ADDENDUM No.3

HERITAGE HIGH SCHOOL

CITY OF LYNCHBURG BID NO.: 14-896
LYNCHBURG CITY SCHOOLS C.I.P. NO.: YS032
3020 WARDS FERRY ROAD
LYNCHBURG, VIRGINIA 24502

FEBRUARY 28, 2014

10 A2.2.5 AD3-A1

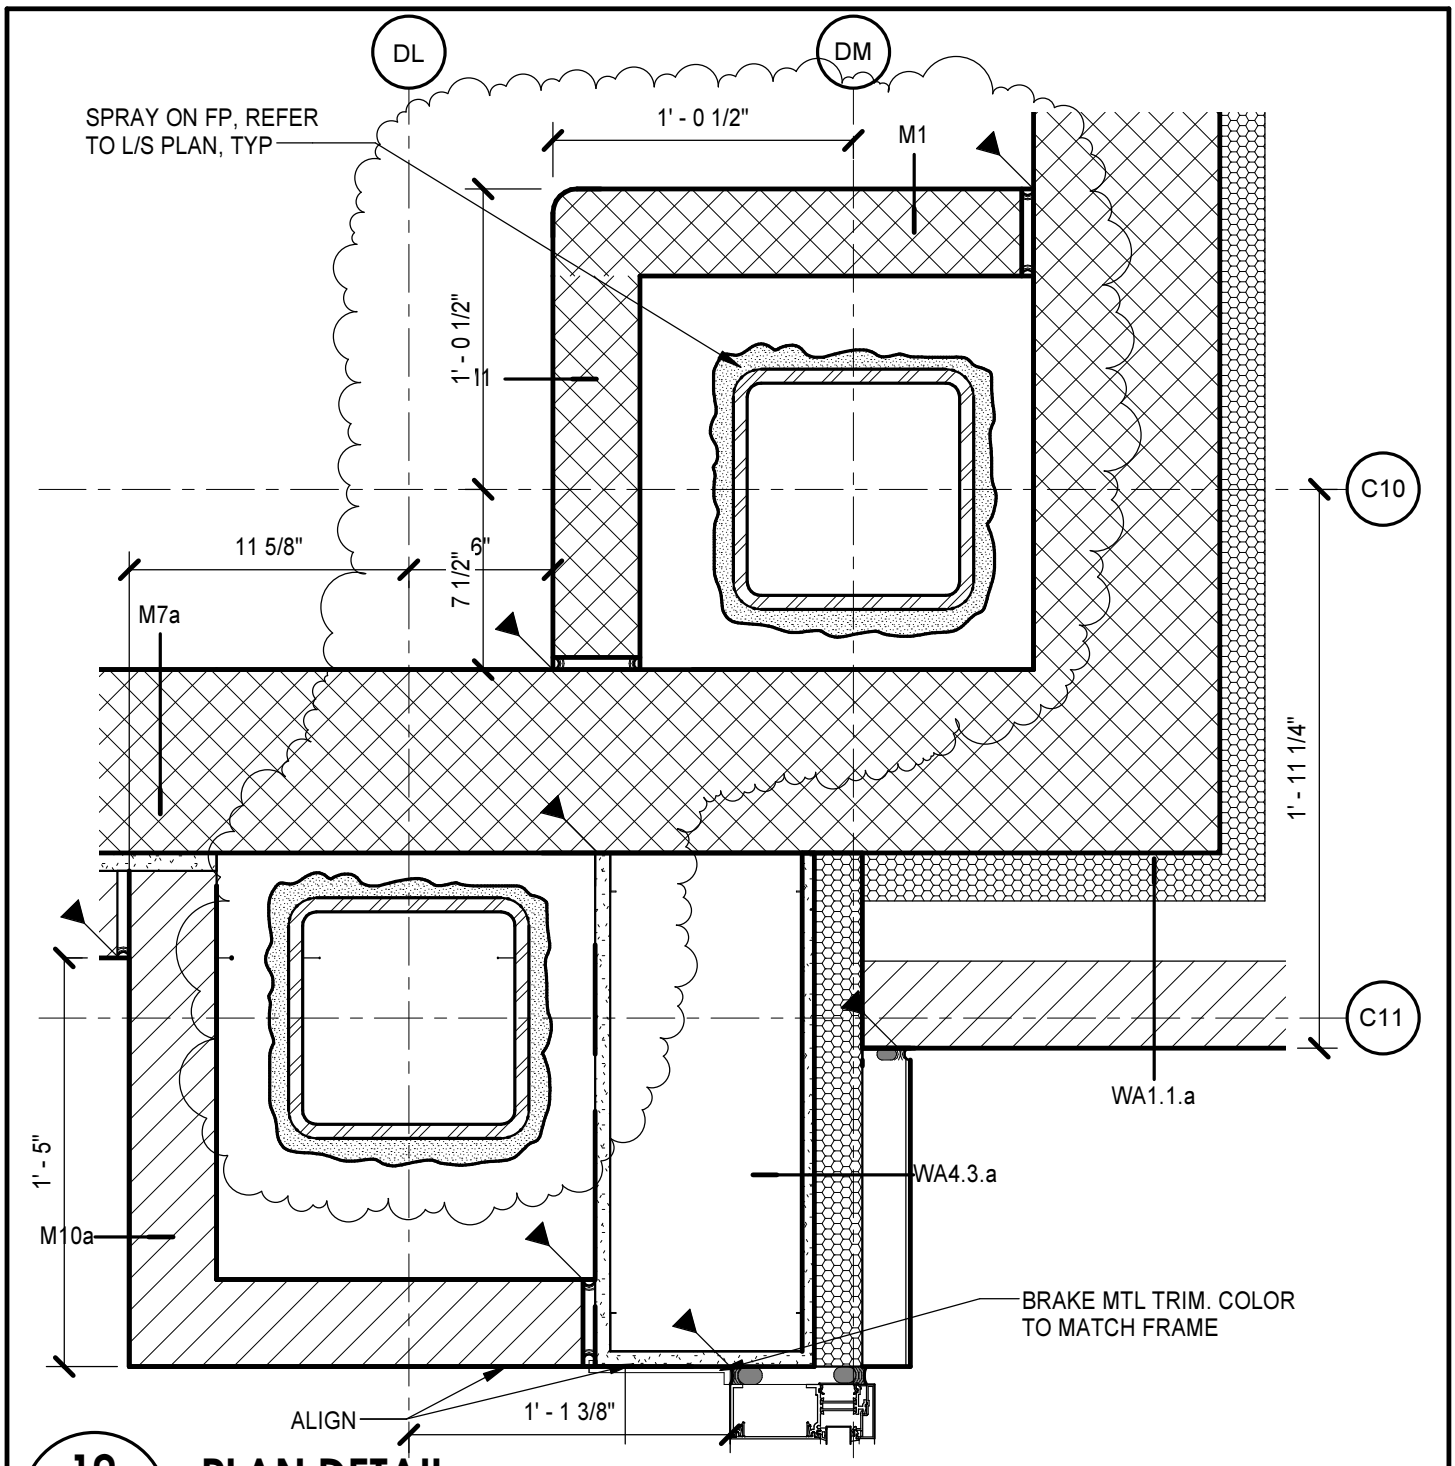
DRAWING A2.2.5 – PLAN DETAILS

1. DELETE Detail 10 and replace with Sketch AD3-A1 attached to this addendum.

6
A1.6.1 | AD3-A6

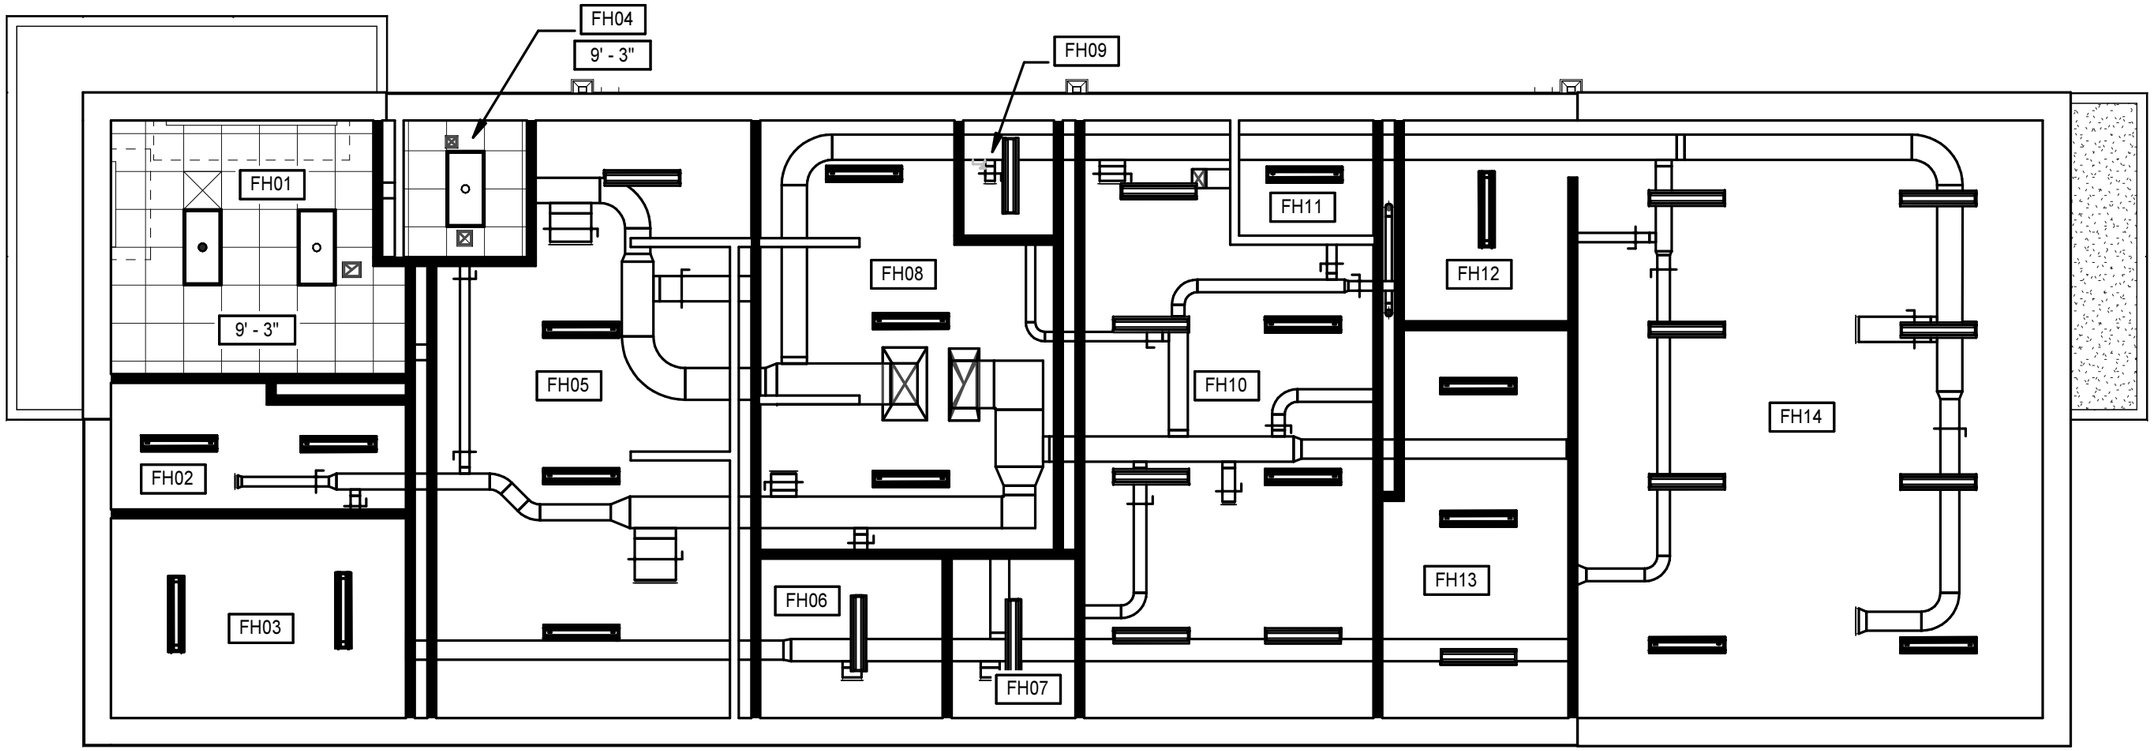
DRAWING A1.6.1 – FIELDHOUSE – PLAN & ELEVATIONS

1. Sketch AD3-A6 attached to this addendum is added to this Drawings.

REVISED PLAN DETAIL 7/S4.11

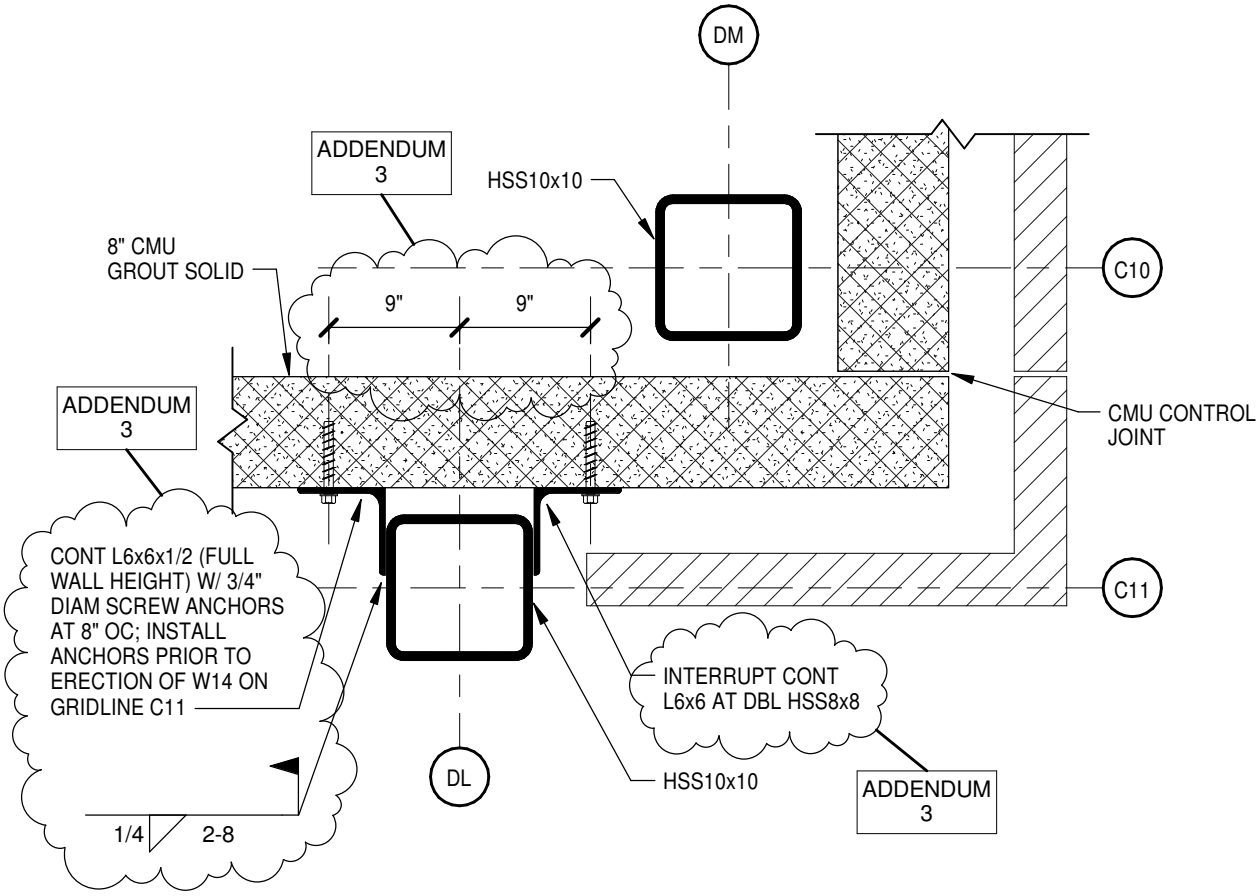
1. REVISE section 7/S4.11 as indicated in attached drawing AD3-S09
2. REVISE section 8/S4.11 as indicated in attached drawing AD3-S10.
3. ADD section 9/S4.11 as indicated in attached drawing AD3-S11.
4. ADD section 10/S4.11 as indicated in attached drawing AD3-S12.
5. ADD section 11/S4.11 as indicated in attached drawing AD3-S13.
6. ADD section 12/S4.11 as indicated in attached drawing AD3-S14.
7. ADD section 13/S4.11 as indicated in attached drawing AD3-S15.
8. ADD section 14/S4.11 as indicated in attached drawing AD3-S16.

DRAWING TITLE:	CONTRACT DWG NO.:	PROJECT:
PARTIAL PART K - HIGH ROOF FRAMING PLAN AT LOCKER BAY K25	**S2.12**	**HERITAGE HIGH SCHOOL** **3020 WARDS FERRY ROAD, LYNCHBURG, VA 24502**

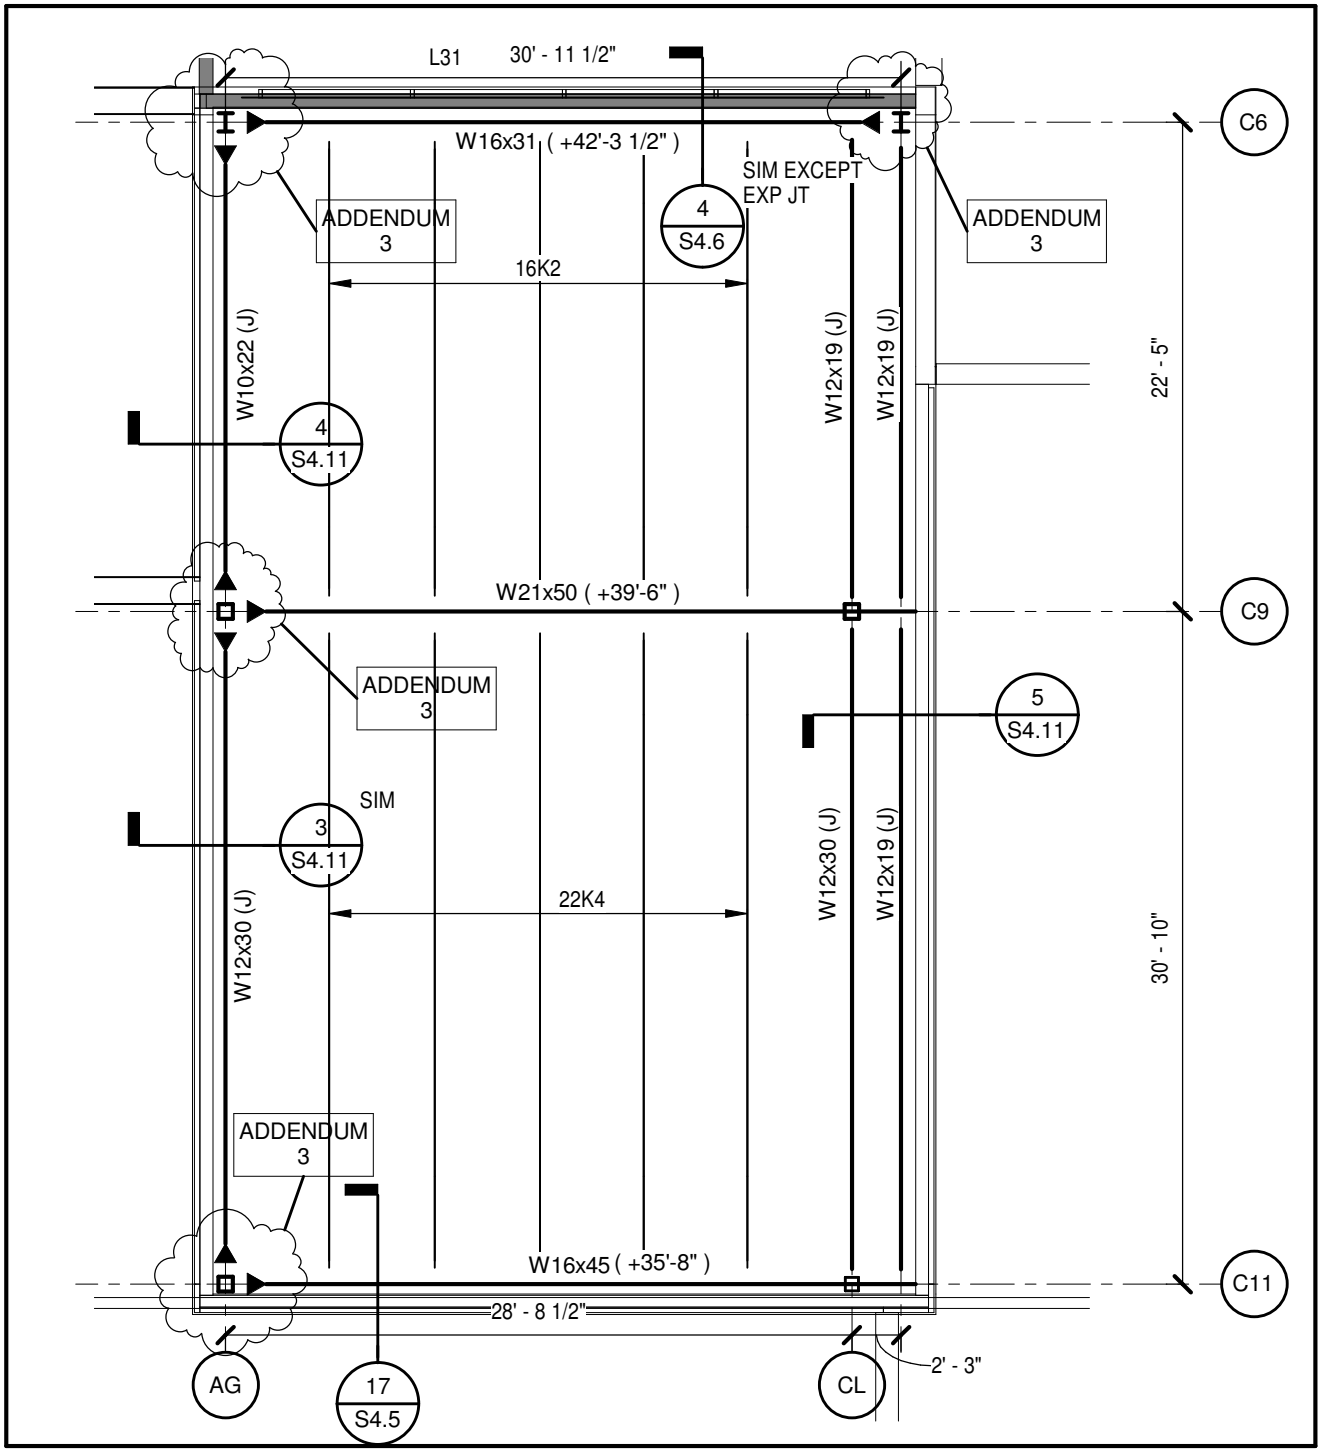
DRAWING S2.12:

1. ADD moment connection symbols to beams in plan as indicated in drawing AD3-S17.

DRAWING TITLE:	CONTRACT DWG NO.:	PROJECT:
REVISED CHILLED WATER SCHEMATIC	**M6.1**	**HERITAGE HIGH SCHOOL** **3020 WARDS FERRY ROAD, LYNCHBURG, VA 24502**

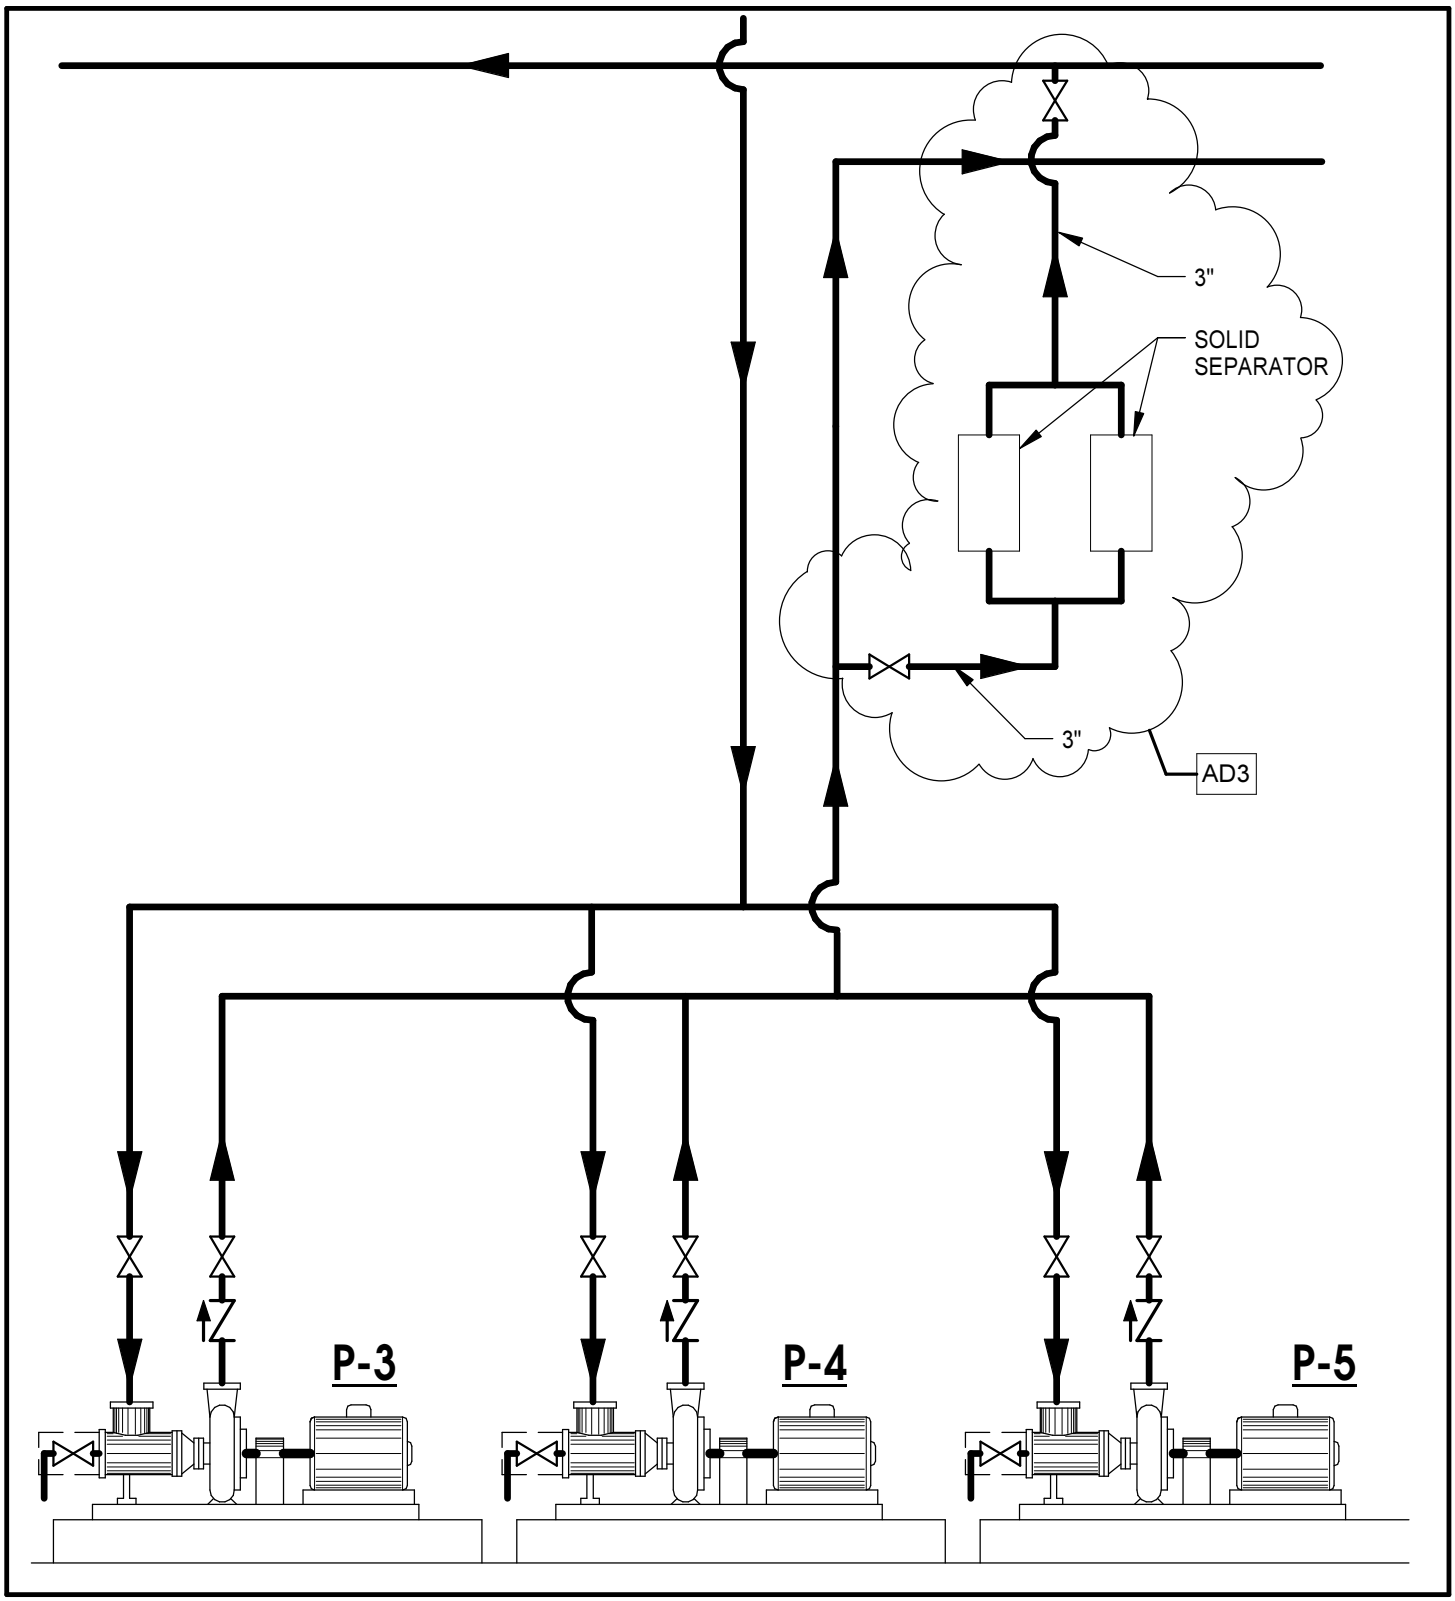
DRAWING M6.1:

1. Revise “Chilled Water System Schematic” as indicated in attached drawing AD3-M1.

DRAWING TITLE:	CONTRACT DWG NO.:	PROJECT:	DRAWN BY:	ATTACHMENT TO:	SUPPLEMENTAL DWG. NO:
REVISIONS TO BASEBALL AND SOFTBALL UPPER LEVEL PRESSBOXES	E1.6	HERITAGE HIGH SCHOOL 3020 WARDS FERRY ROAD, LYNCHBURG, VA 24502	JAT	AD3	AD3-E1.6-1
			DATE: 02/28/14	PROJECT NO: 520910

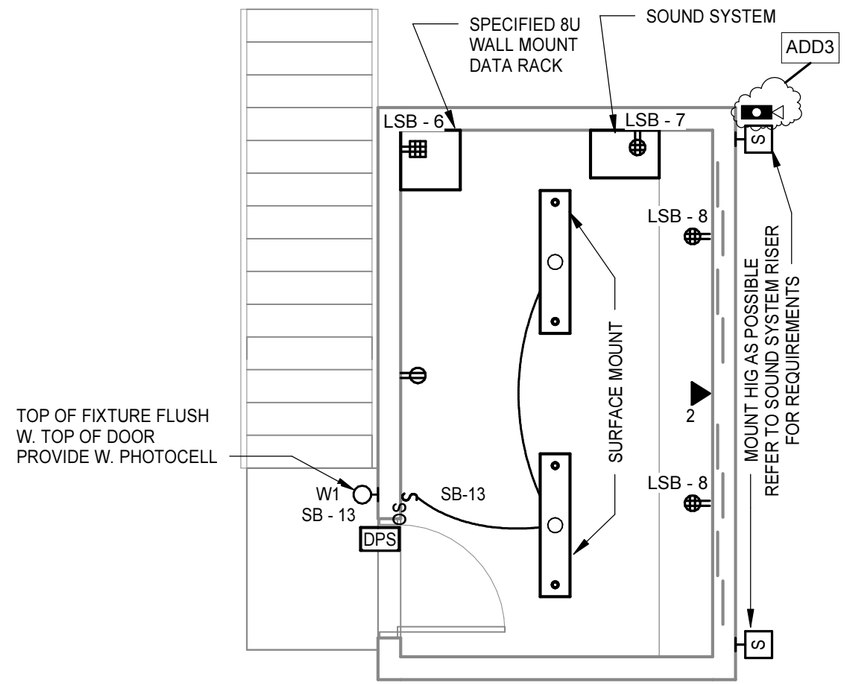
DRAWING E1.6:

1. Revise Electrical – Baseball Press Box and Softball Press Box per sketch AD3-E1.6-1
2. Revise lighting contactor detail to include "NOTE 1: PROVIDE IN FIELD HOUSE ELECTRICAL ROOM."
